**Project:** “Development of Sewerage Treatment Plants on Hybrid Annuity PPP basis at Kanpur, UP”.  
**Subject:** Site visit report of 30 MLD STP and associated IPS & 130 MLD STP at Jajmau

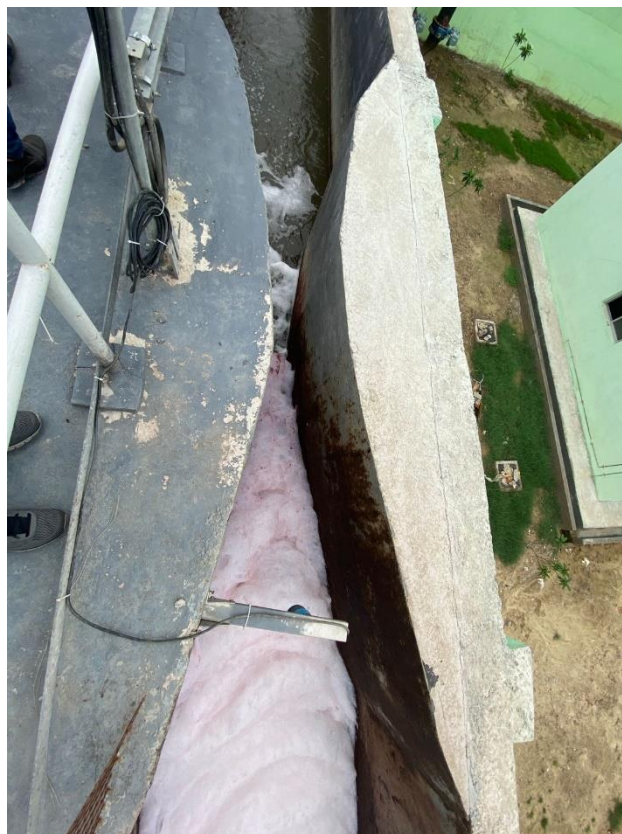
- The concessionaire has not maintained the required distances for installation of flow meter at the common discharge of pumps as per the manufacturer recommendations, which might result in inaccurate flow values at later stage.
